DEPARTMENT OF THE NAVY
ATLANTIC DIVISION
NAVAL FACILITIES ENGINEERING COMMAND
1510 GILBERT ST
NORFOLK VA 23511-2699

Re: Additional Fieldwork at Sites 2E, 15, and 24
at NAS Oceana

PROPOSED SUPPLEMENTAL FIELDWORK

Figure 2-2-6
ORGANIC COMPOUNDS
IN GROUNDWATER
AT SITE 2E DURING
PHASE I AND PHASE II
SAMPLING

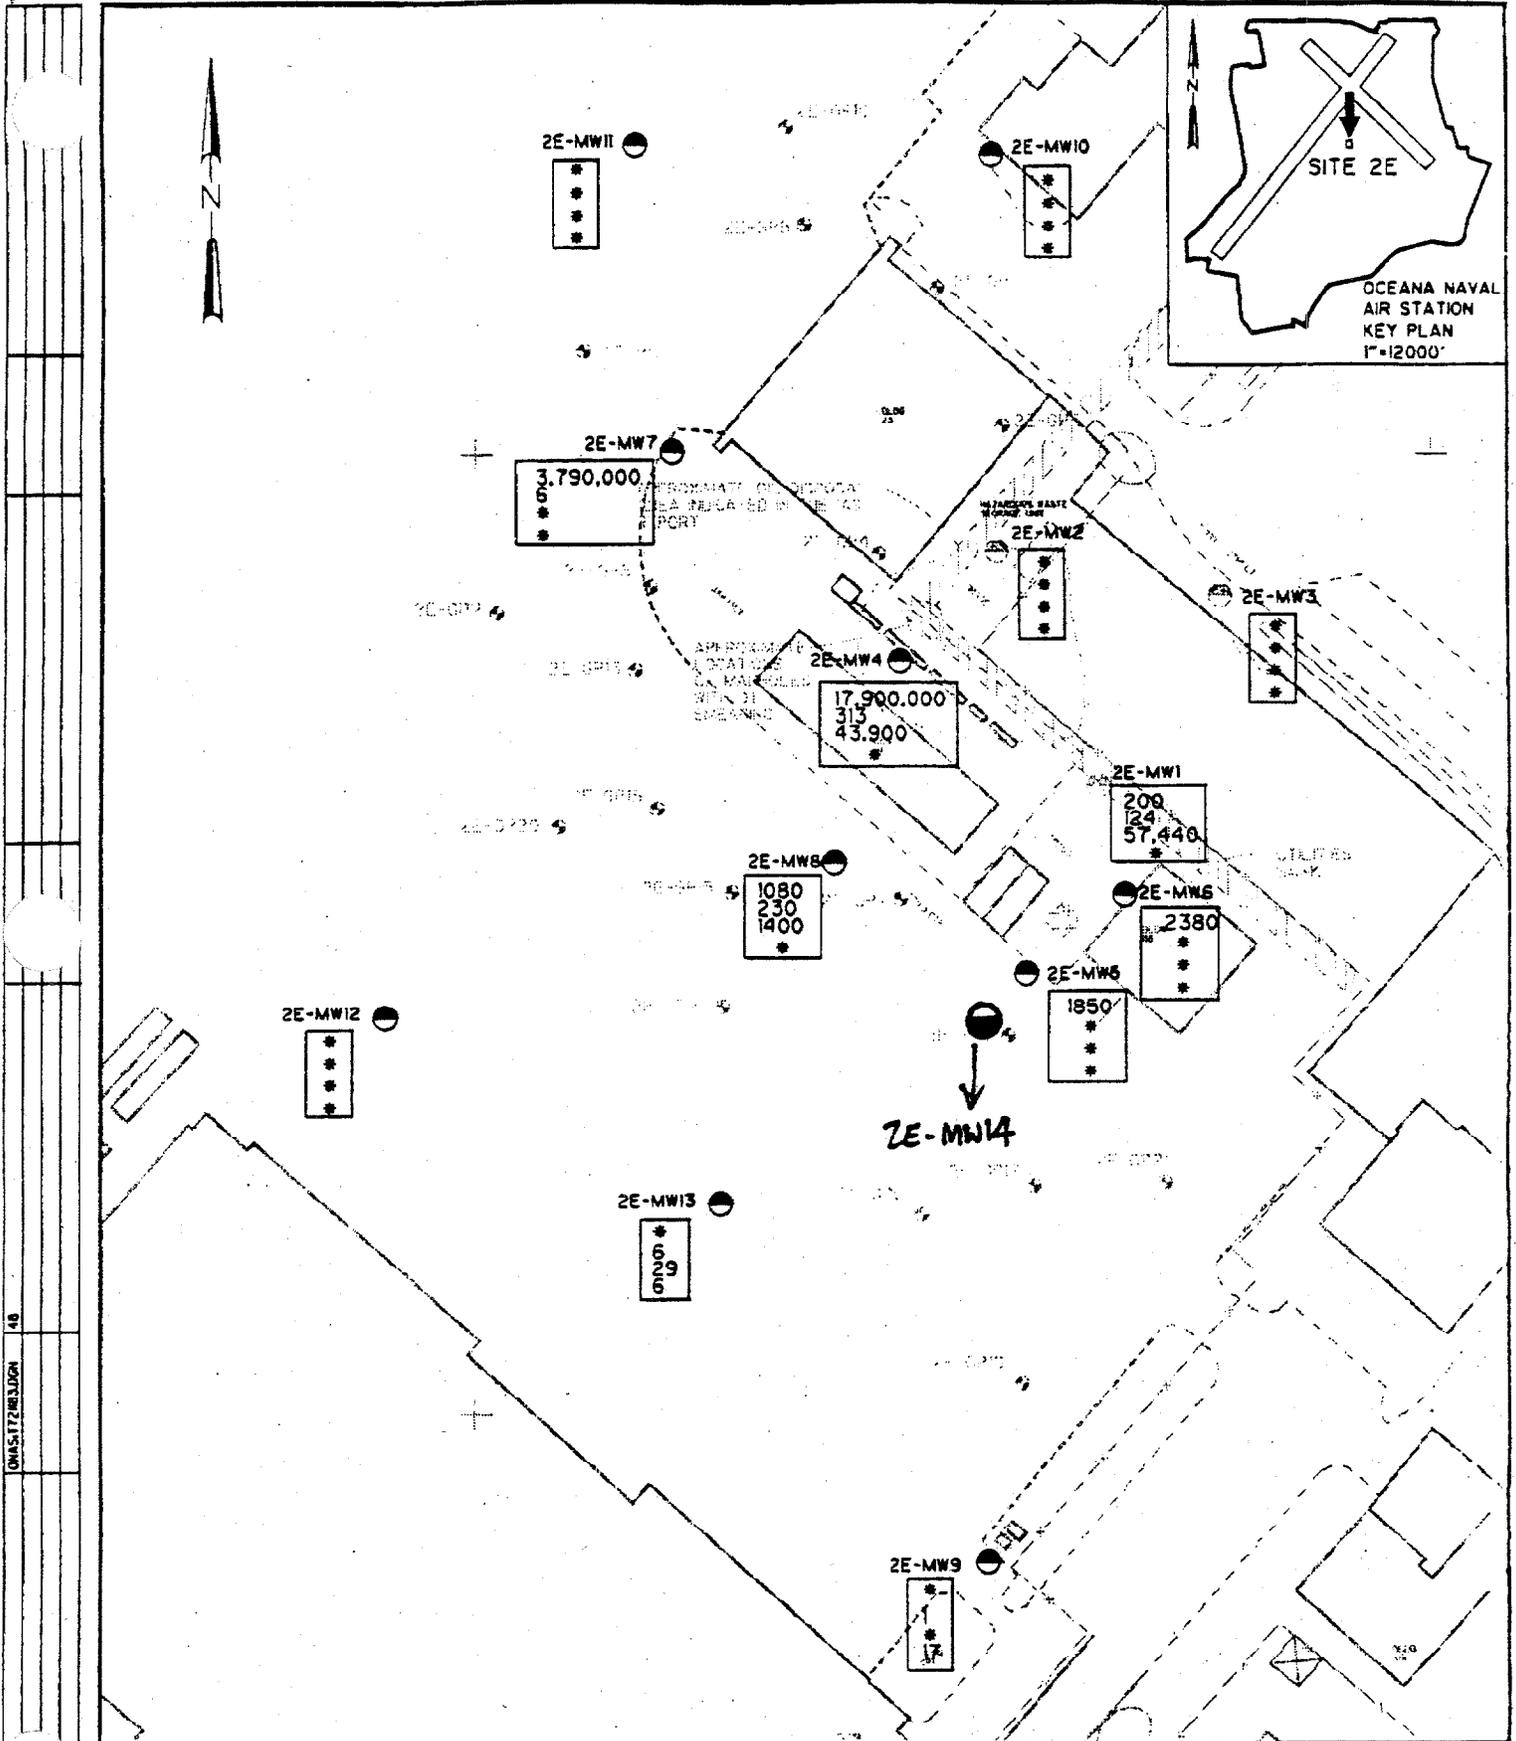
→ 6 in-situ samples + 1 vac. split
→ 2 MW's + 1 deep in a high con. air-area.

Six groundwater geoprobes should be taken analyzed in the on-site laboratory for VOCs with 1 confirmatory sample sent to the lab for 8240 VOCs. Two shallow wells shall be installed and sampled for the 8240 VOCs, TPH, PAH, and total and dissolved lead, mercury and zinc. One deep well will be installed in a high contamination area. Six selected wells from the previous RFI (MW-7, 9-13) will be selected and sampled for 8240 VOCs, TPH and PAH. New wells will be surveyed and water levels taken.

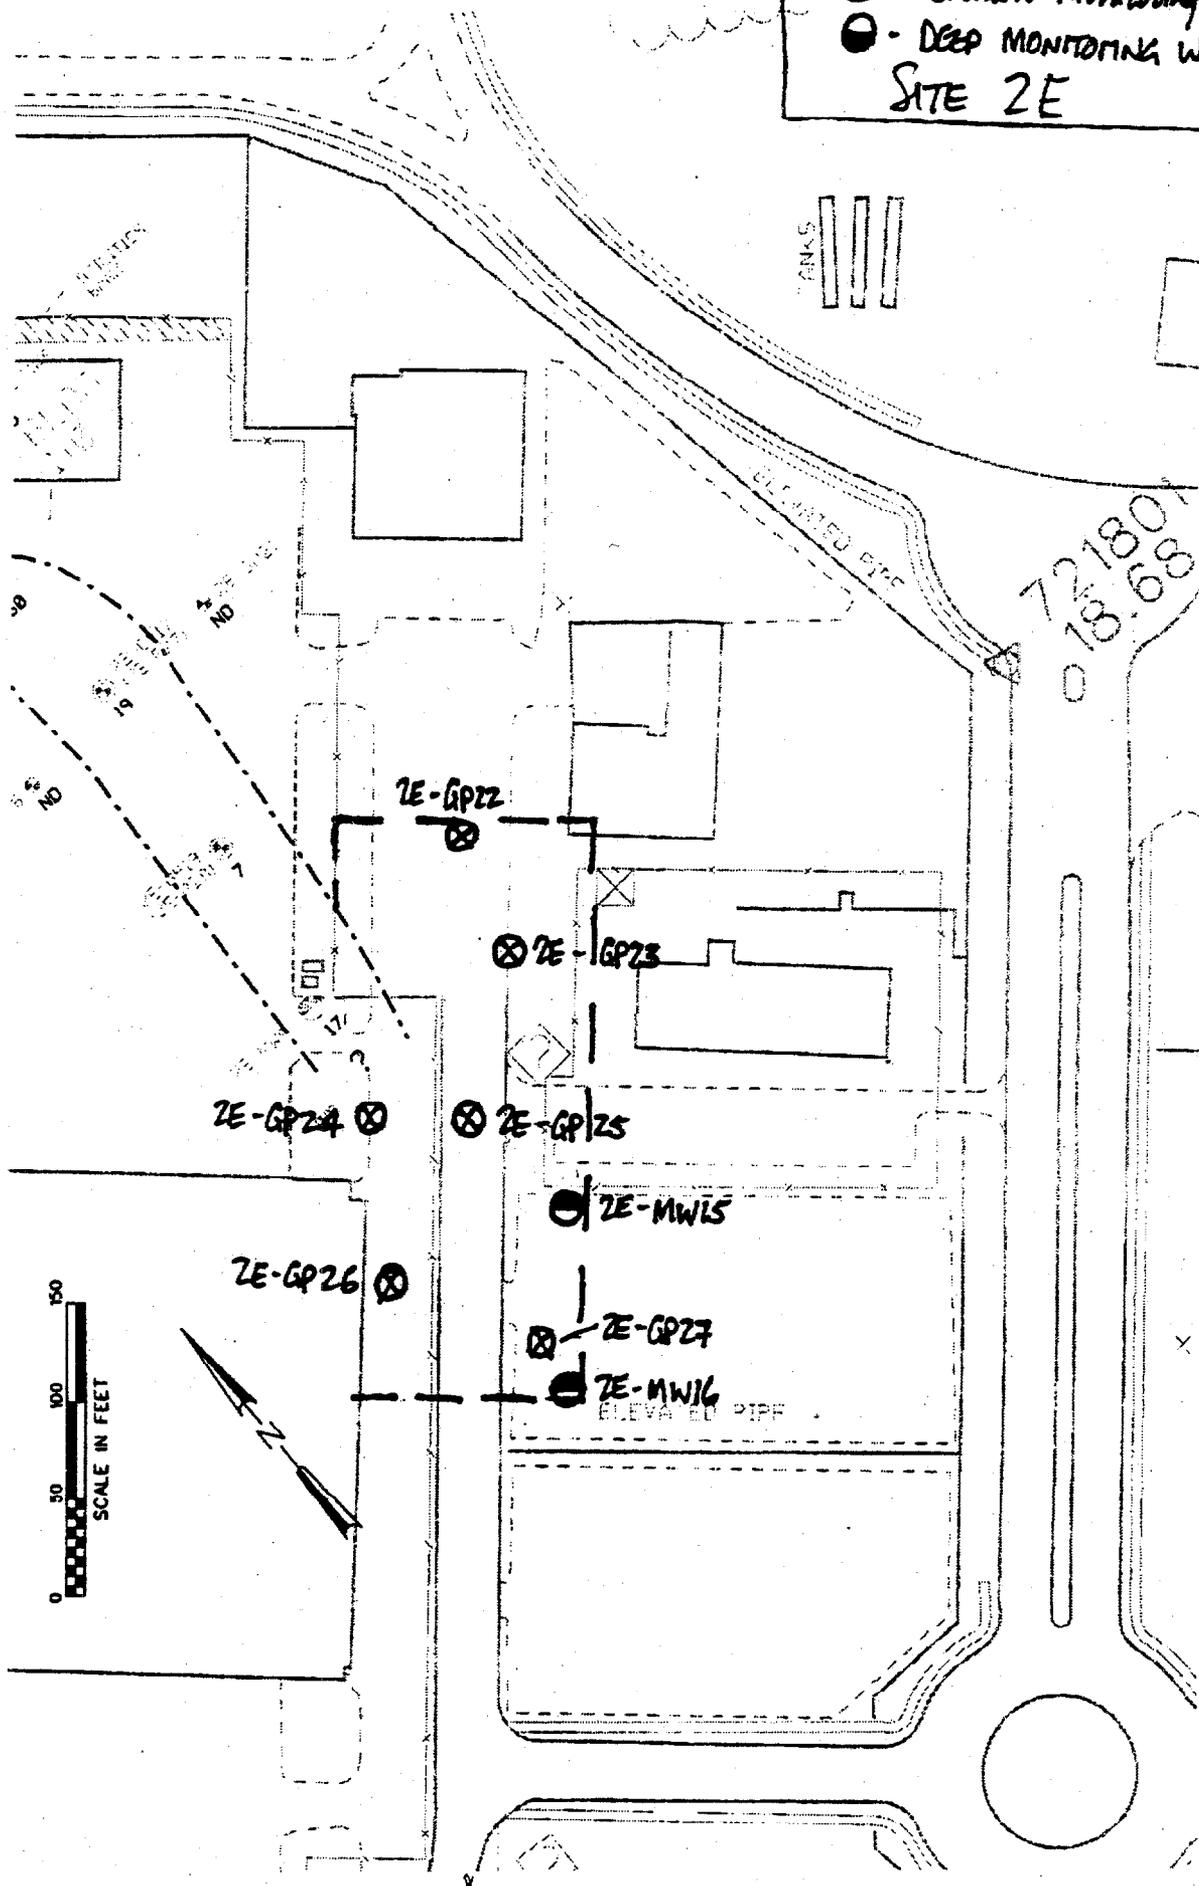
● 2 Shallow MW across

● 1 6" Pumping Well

● 1 2" Piezometer

Five groundwater geoprobes will be taken south of well 15-MW-15 and 2 wells shall be installed. The samples will be sampled for BTEX and TPH.

Site 15 - Take 5 additional soil samples at site 15. These sites will be determined by the field engineer and will be approved by the RPM immediately upon designation. Analyze the 3 previously designated soil borings for NO₃, NH₄, PO₄ and TKN analysis.

SITE 24

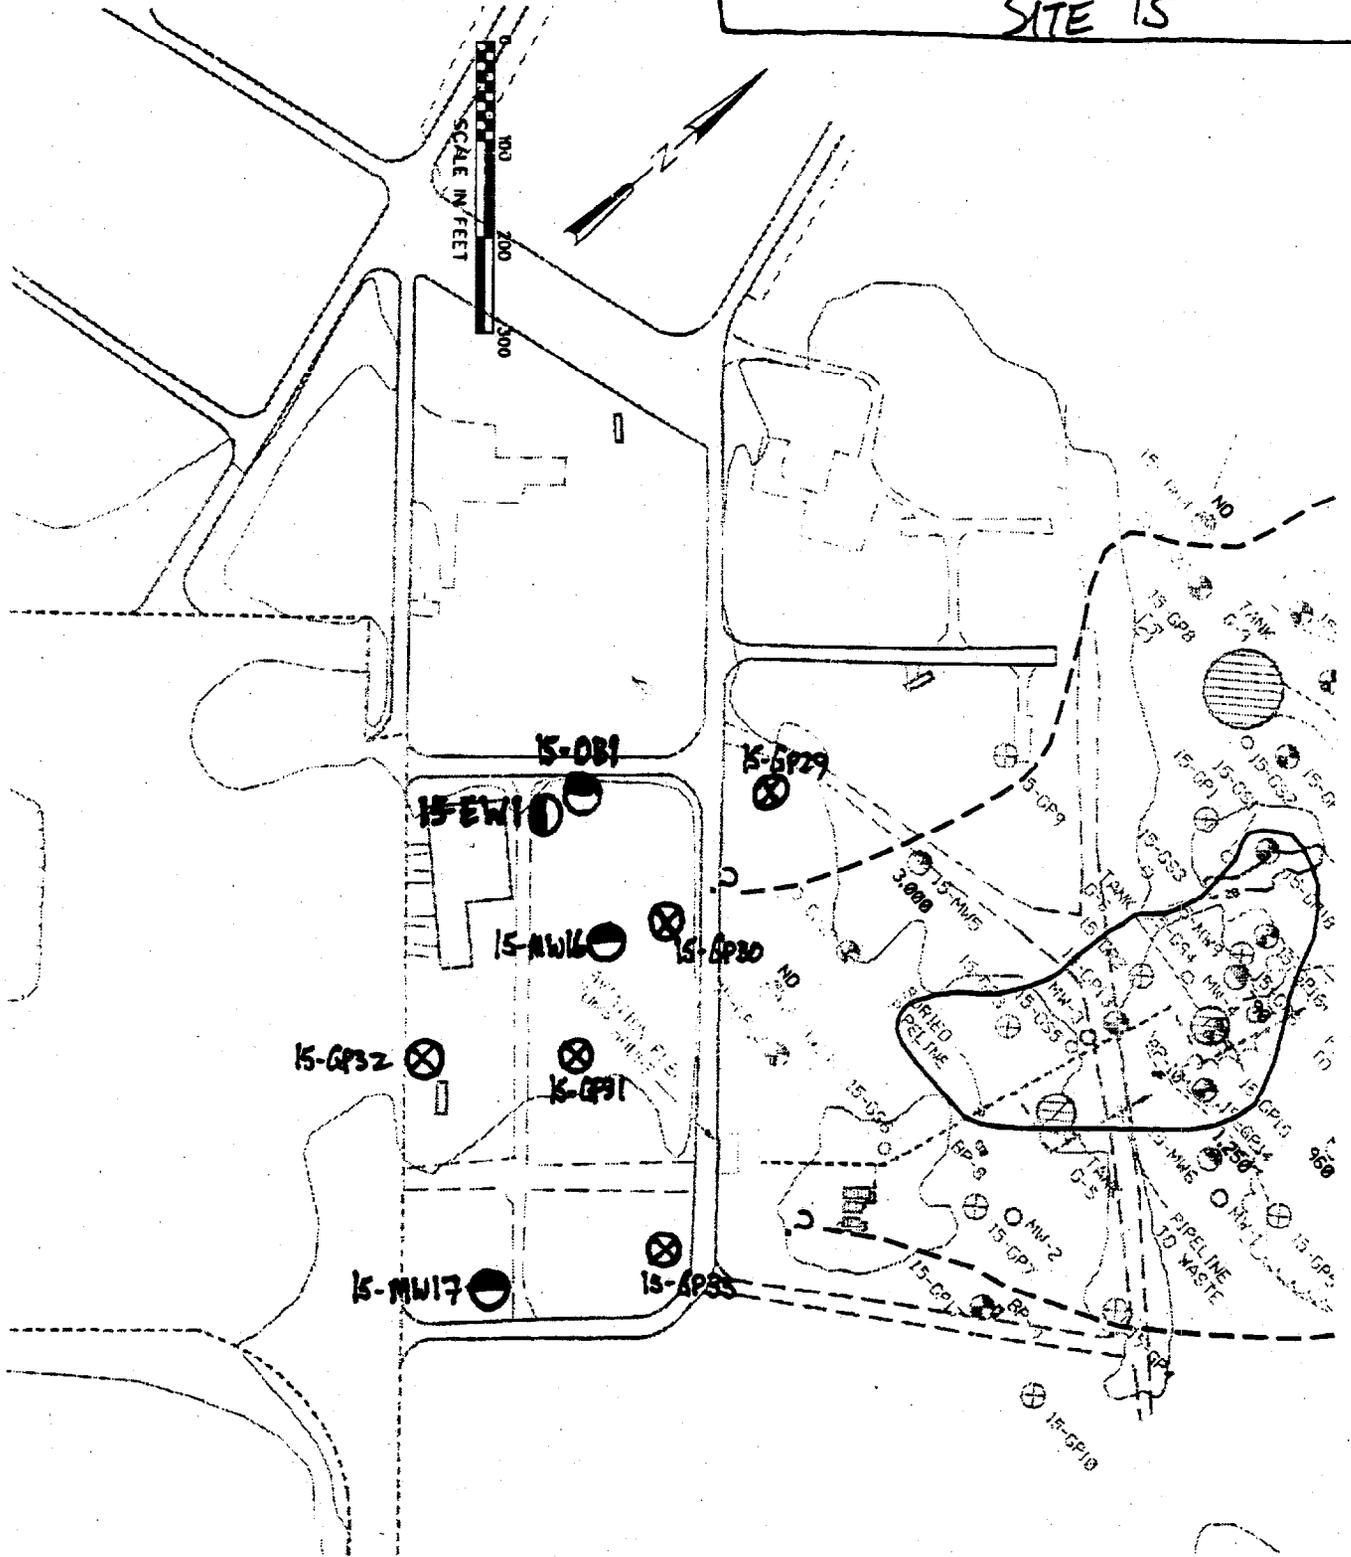
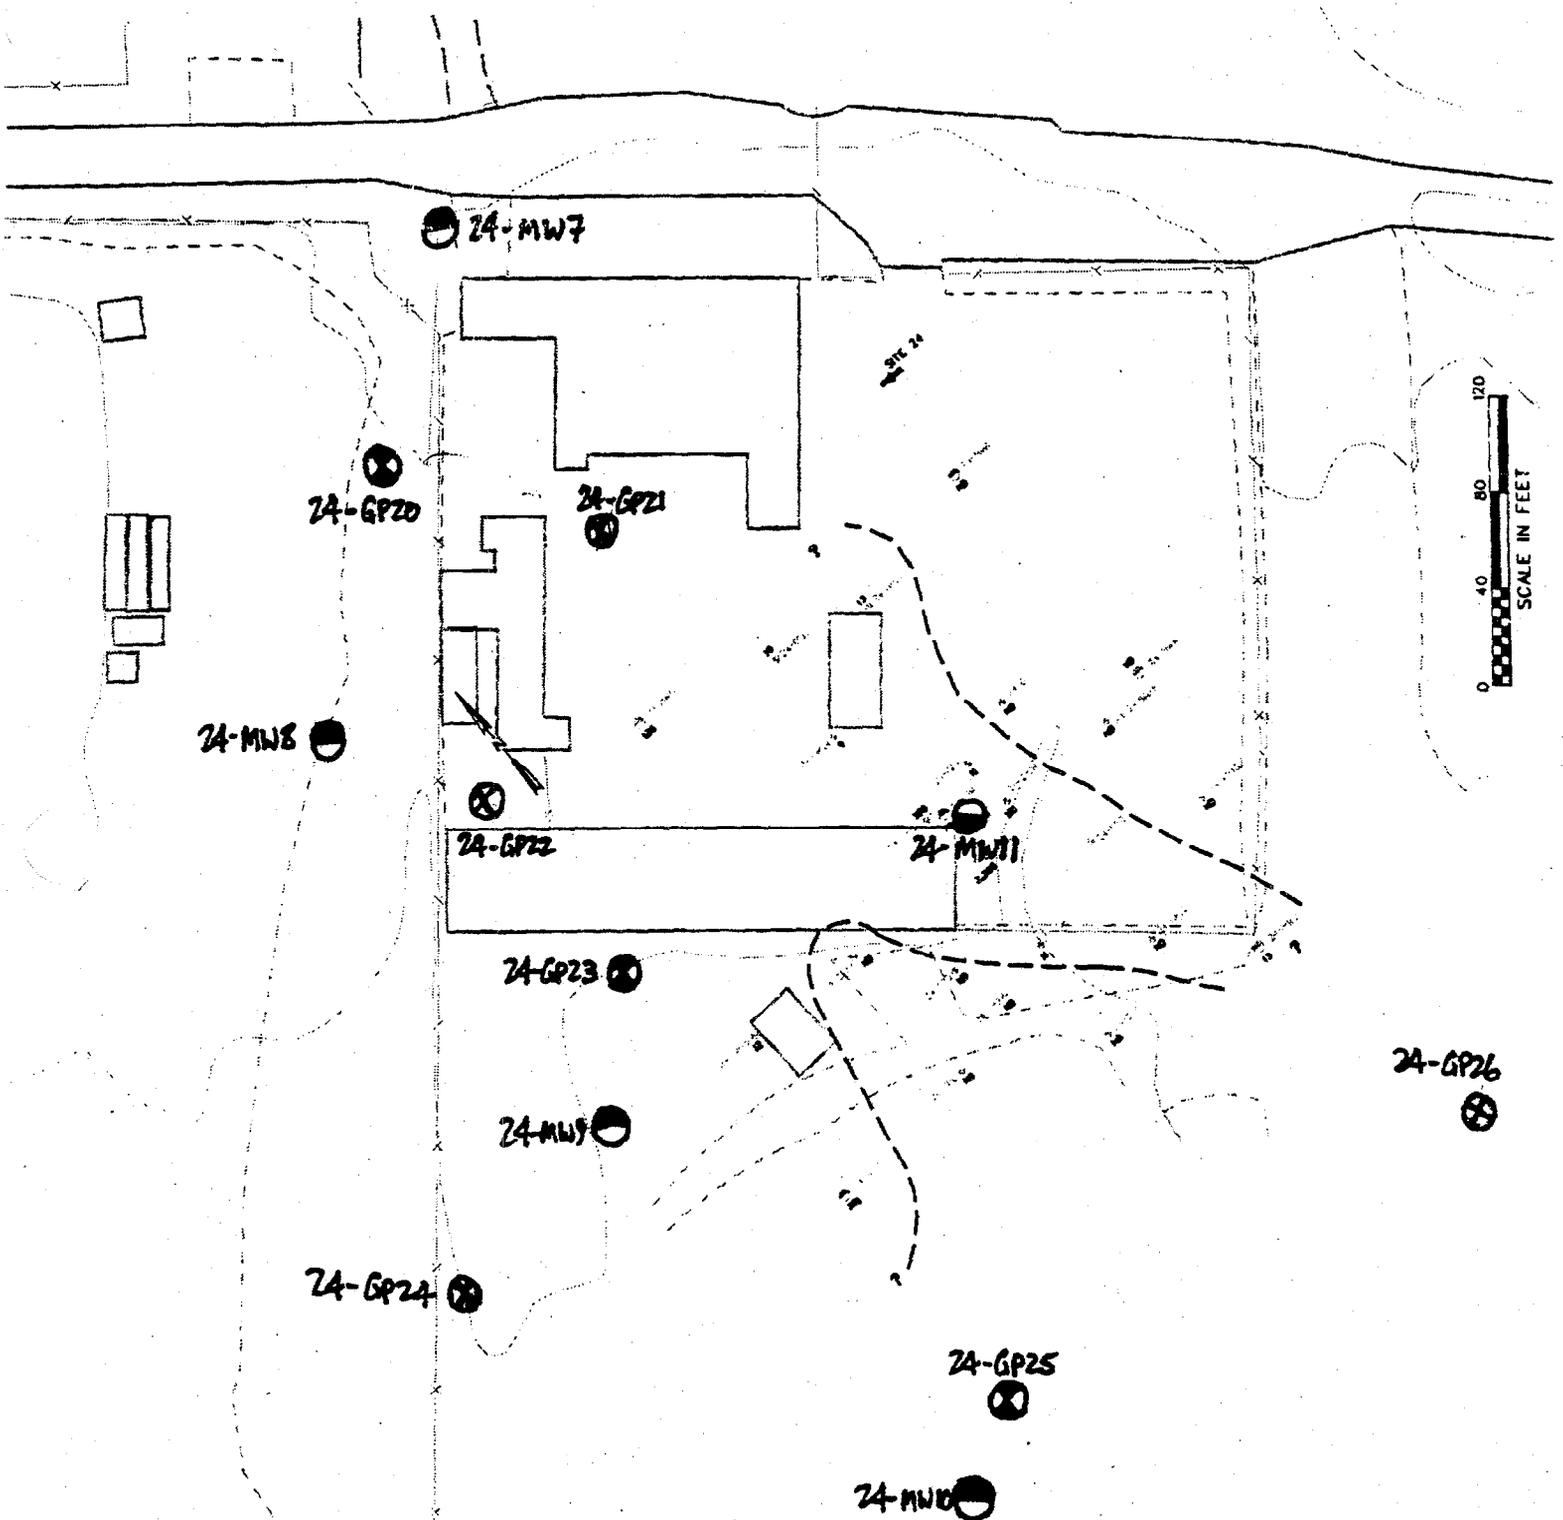
- ⊗, ⊙ • 10 Geoprobe from 7 locations. $\left\{ \begin{array}{l} 2 \text{ SPLITS} \\ 1 \text{ SHALLOW } 8290 \\ 1 \text{ DEEP.} \end{array} \right.$
- ⊙ • 4 Shallow MWs outside contamination
- ⊙ • 1 DEEP MW IN HIGH CONTAMINATION AREA.

Seven groundwater geoprobe locations including three double depth samples for a total of 10 samples should be taken and analyzed in the on-site laboratory with one shallow and one deep sample shipped off site for 8240 VOCs. Four wells should be installed outside of the contamination and should be sampled for 8240 VOCs. One deep well should be installed in a highly contaminated area and sampled for 8240 VOCs. MW-2, 3, and 4 should be resampled for 8240 VOCs.
